Subject: City of Hastings Summergate MUSA Expansion Comprehensive Plan Amendment, Review File 22299-3

REVIEW RECORD

Summergate MUSA Expansion Comprehensive Plan Amendment

Review File No. 22299-3, Business Item No. 2022-26

Figure 2. Location Map Showing Existing Community Designation

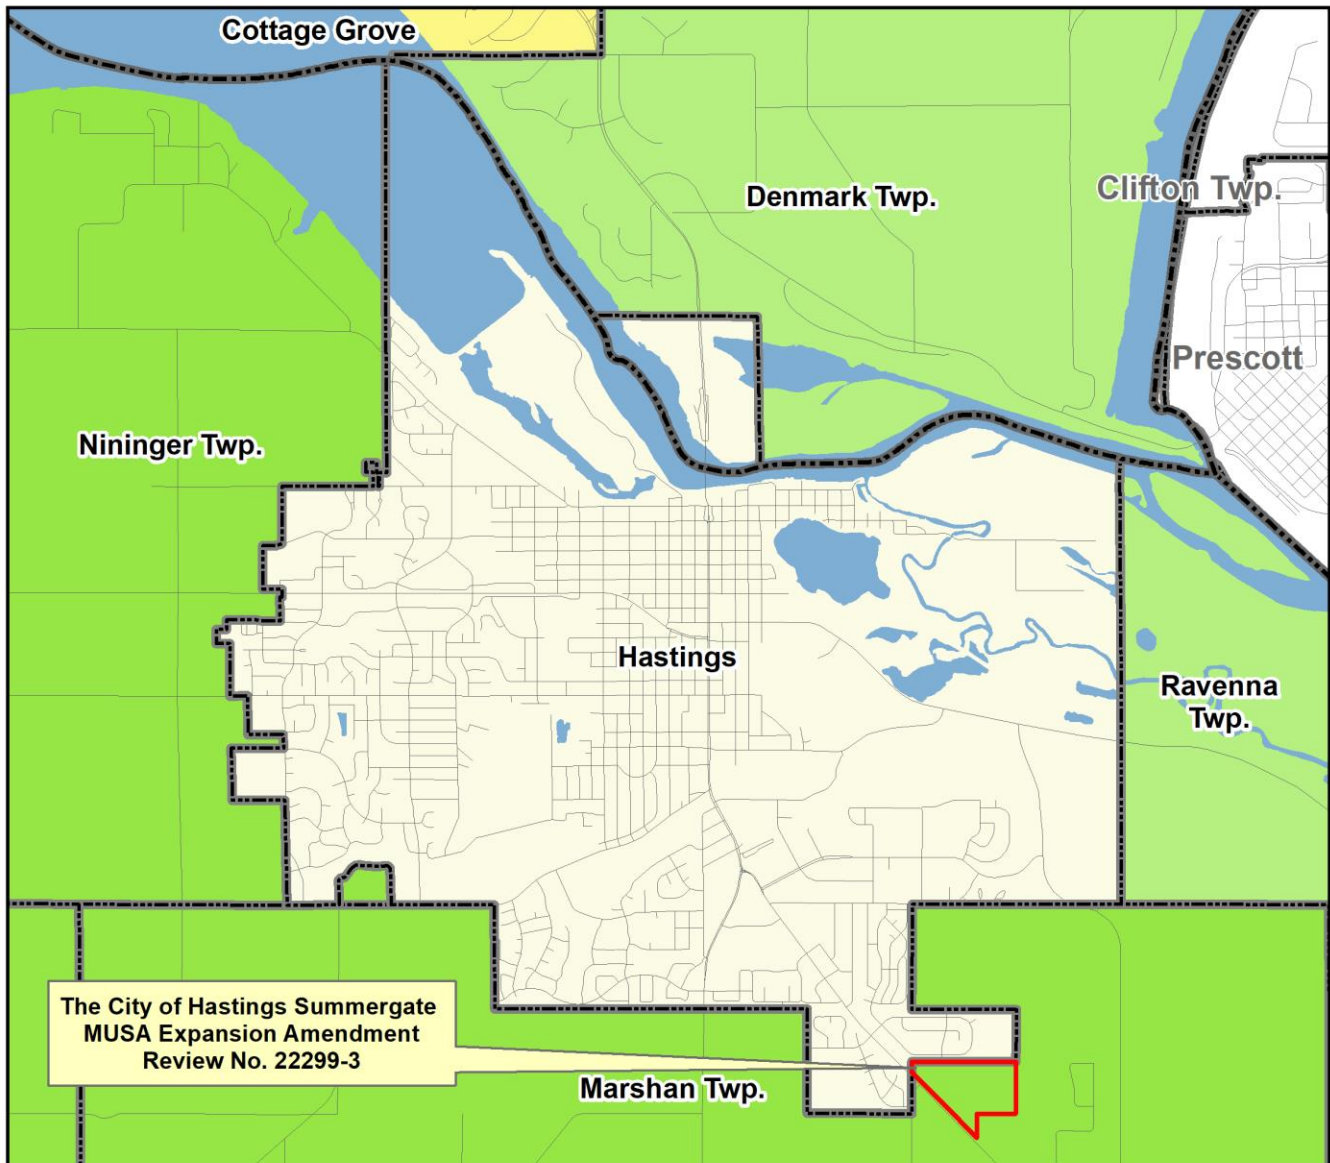
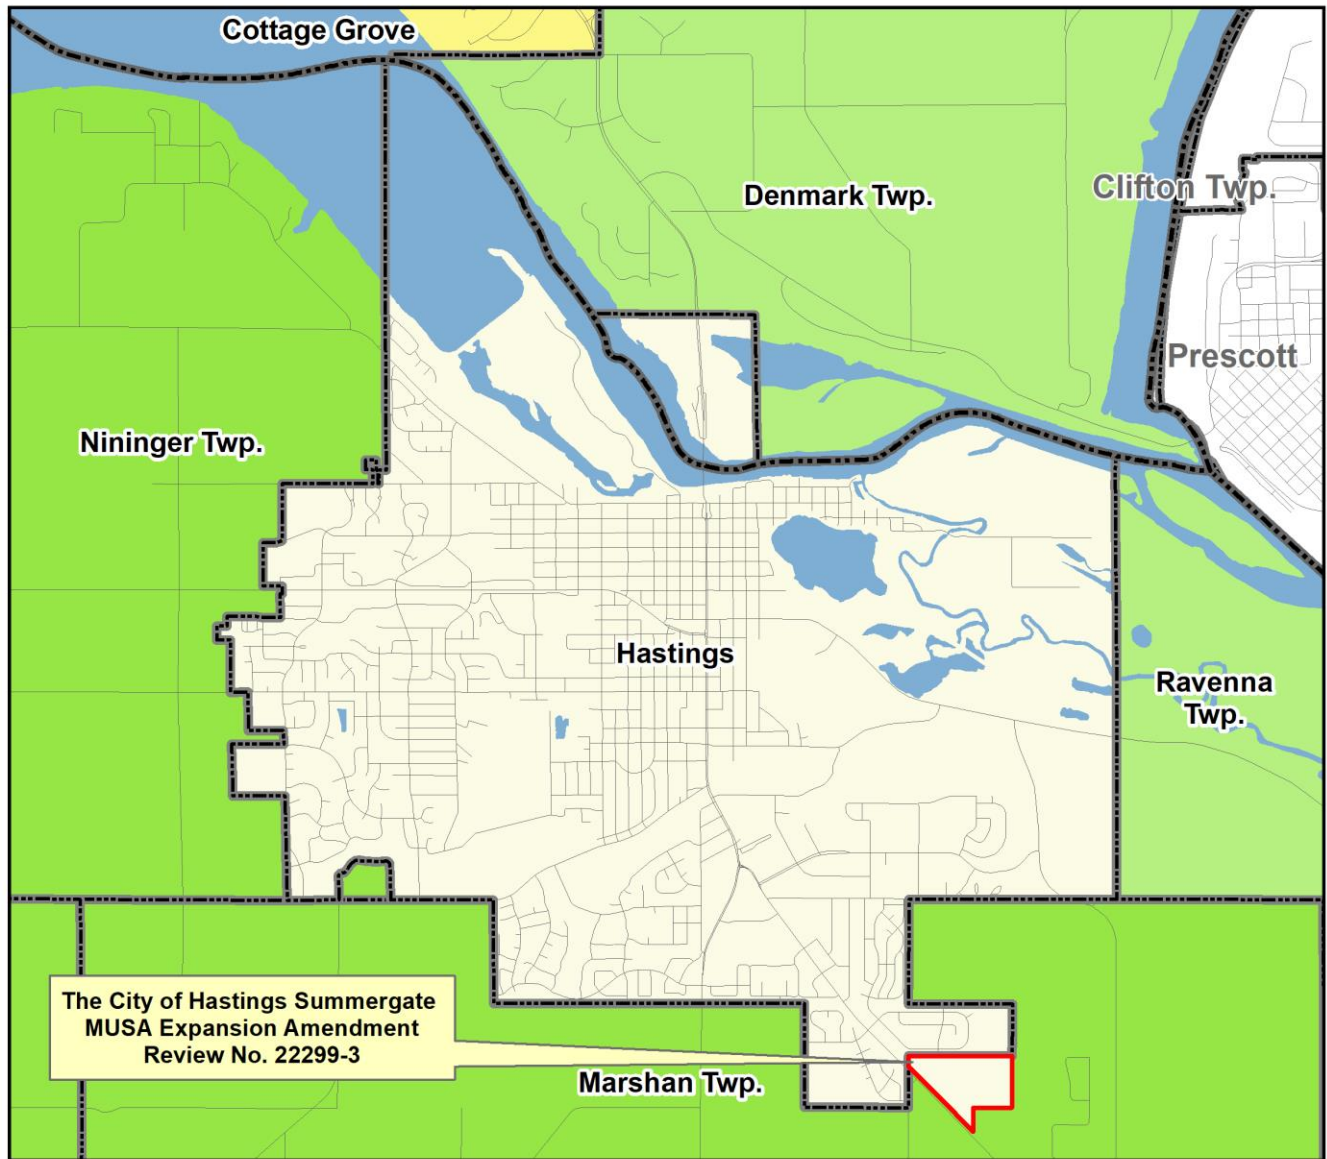
1. Authorize the City of Hastings to place its comprehensive plan amendment into effect.
2. Find that the amendment does not change the City's forecasts.
3. Revise *Thrive MSP 2040* to change the Community Designation for the amendment property from Agriculture to Emerging Suburban Edge as shown in Figure 2.
4. Advise the City to implement the advisory comments in the Review Record for Parks and Forecasts.

The amendment requires a change to the current Community Designation of Agricultural to Emerging Suburban Edge as a result of the recent annexation. This is the City's second amendment to its 2040 Comprehensive Plan.

Thrive MSP 2040 identifies the City as an Emerging Suburban Edge Community. The amendment proposes to expand the Metropolitan Urban Service Area (MUSA) boundary to incorporate 71.9 acres from Marshan Township that was recently annexed into the City, and assign the newly annexed land as Low Density Residential, which has been included on Table 1 (below). While in the Township previously, the annexed property was designated as Agricultural. The recent annexation and the City's plans to extend sanitary sewer for the development of this property necessitate a change to the community designation from Agricultural to Emerging Suburban Edge consistent with the primary designation for the City.
